**U.S. Nuclear Regulatory Commission Plan  
for Monitoring Disposal Actions Taken by  
the U.S. Department of Energy at the  
Savannah River Site Saltstone Disposal Facility  
in Accordance With the National Defense  
Authorization Act for Fiscal Year 2005,  
Revision 1**

September 2013

U.S. Nuclear Regulatory Commission  
Office of Federal and State Materials  
and Environmental Management Programs  
Washington, DC 20555-0001

Figure 3-1: Conceptual Illustration of the Components of SDF Closure Cap and Additional Engineered Layers above the Disposal Structures

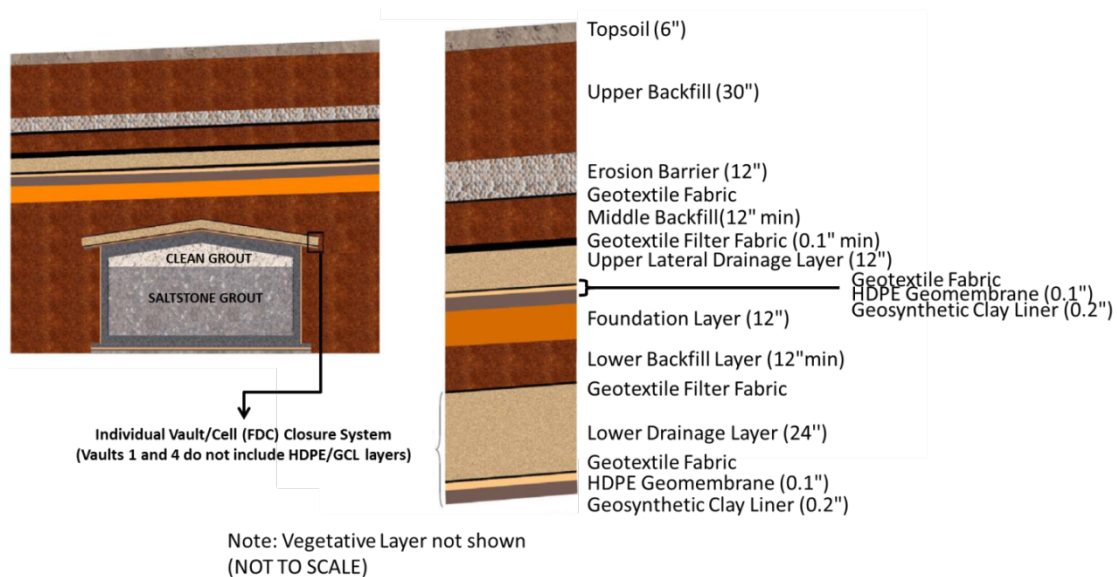
In the DOE 2009 PA, the performance of the cap was based on the preliminary DOE design of the cap. NRC will monitor the development of specific designs for the cap and will determine if those designs are likely to significantly alter the projected cap performance in the DOE 2009 PA. Prior to any construction activities, NRC staff should review the specifications for cover construction materials and the quality assurance/quality control procedures for ensuring that those materials meet the specifications. During construction, NRC staff should observe the placement of those materials and the quality control testing to determine whether or not the as-built cover meets the design specifications.

Based on the current cap design and model results, NRC staff should focus on the assumed performance of the HDPE/GCL composite layer and the lower foundation layer. Model support for the cap may include pilot-scale testing of the cap design; laboratory results and literature reviews related to the performance of cap components; studies of analog sites to estimate long-term infiltration; and revised simulations of cap performance.

Figure A-1: Location of Z-Area Wells (from SRNS-TR-2012-00125)

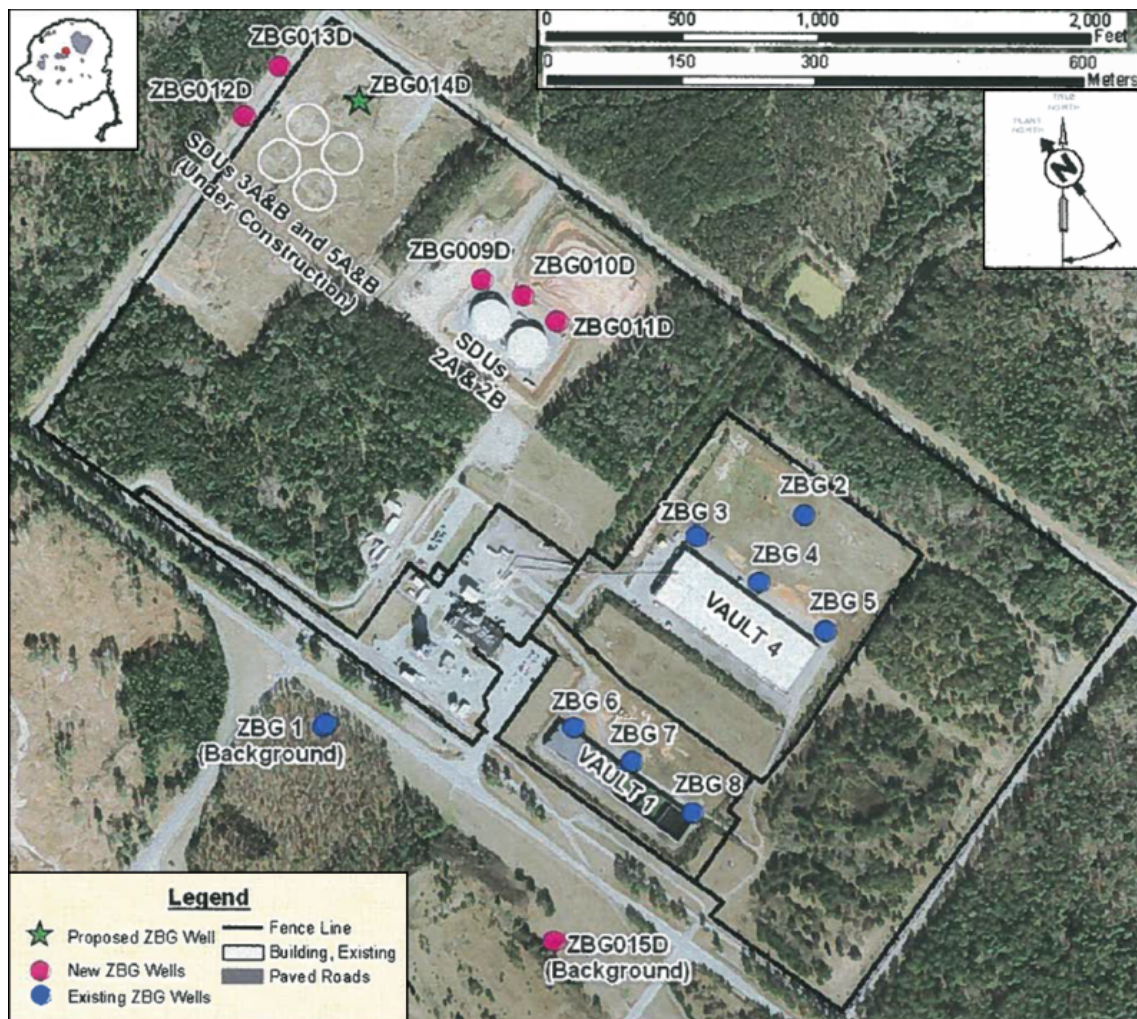
According to the Groundwater Monitoring Plan for the Z-Area Saltstone Disposal Facility (WSRC-TR-2005-00257), DOE plans to monitor the groundwater in three water table wells located downgradient of SDS 4 (designated ZBG3, ZBG4, and ZBG5) as well as in one background well (designated ZBG1). In addition, three wells (designated ZBG6, ZBG7, and ZBG8) have been installed downgradient of SDS 1. In the future, if new disposal structures are constructed downgradient of the current wells, then new wells will be installed within 30 m [100 ft] downgradient of the new disposal structures. See below Figure A-1 containing a more recent image of monitoring well locations at the SDF, which came from "Saltstone Disposal Facility Class 3 Landfill Groundwater Monitoring Midyear Report for 2012" (SRNS-TR-2012-00125), dated July 2012.

NRC staff reviewed aspects of the groundwater monitoring program during onsite observation visits in October 2007 and March 2008 (NRC, 2008a; NRC, 2008b). During the October 2007 visit, NRC staff reviewed procedures relating to groundwater monitoring well installation,
